Access Compliance Report Public Rights-of-Way (Curb Ramps)

Main Street: N/A Cross Street: ESPERANZA_RD Location: NE

ADA ID: RPAT210923141316 Ramp Type: Type 7 - Directional 2 Initial Pass/Fail: Fail Overall Compliance: No Severity Score: 15

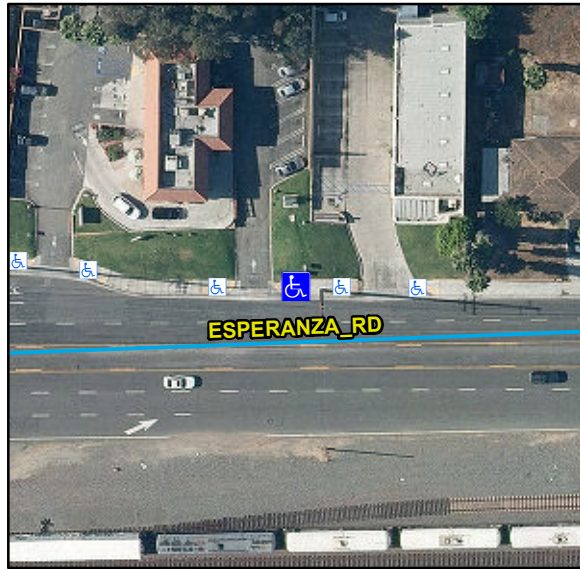
Compliance	Description	Data	Compliance	Description	Data
N/A	Ramp Length (in)	68	N/A	Flare Type LT	
Yes	Ramp Width (in)	94			N/A
No	Ramp Run Slope (%)	10.7	N/A	Flare Slope LT (%)	N/A
Yes	Ramp Cross Slope (%)	1.7	N/A	Flare Traversable LT	N/A
N/A	Grade Break	N/A	N/A	Flare Type RT	
N/A	Grade Break Slope (%)	N/A			N/A
N/A	Grade Break Cross Slope (%)	N/A	N/A	Flare Slope RT (%)	N/A
	Addl Para Ramp Left?	N/A	N/A	Flare Traversable RT	N/A
	Addl Para Ramp Right?	N/A	N/A	DWS Provided	N/A
N/A	Landing Present	N/A	N/A	DWS Contrast	N/A
N/A	Landing Length (in)	N/A	N/A	DWS Length (in)	N/A
N/A	Landing Width (in)	N/A	N/A	DWS Full Width	N/A
N/A	Landing Run Slope (%)	N/A		DWS Offset Type	N/A
N/A	Landing Cross Slope (%)	N/A	N/A	DWS Left Offset (in)	N/A
N/A	Landing Movement Obstructed?	N/A	N/A	DWS Right Offset (in)	N/A
	Landing Movement Type	N/A			
N/A	Landing Shared	N/A			
N/A	Marked Crosswalk 1	No	N/A	Clear Space	N/A
	Crossing 1 Direction	W	N/A	Clear Space To Crosswalk (in)	N/A

N/A	Marked Crosswalk 1 Width (in)	N/A			
N/A	Ramp Inside Crosswalk 1	N/A			
	Crossing 1 Slope (%)	2			
	Crossing 1 Cross Slope (%)	5.2			
N/A	Gutter Ponding	N/A	N/A	Curb Slope	9.6
Yes	Gutter Lip Height (in)	0		Road Run Slope (%)	2.8
N/A	Gutter Run Slope (%)	N/A		Road Cross Slope (%)	7.6
N/A	Gutter Cross Slope (%)	N/A		Parallel Ramp Side	Left
Yes	Overall Surface Condition	Acceptable	Yes	Perp Joint Present	Yes
	Cross Gutter Present?	Yes		Spandrel Present?	Yes
	Replace Cross Gutter?	No		Replace Spandrel?	No

Remove & Replace Entire Ramp.
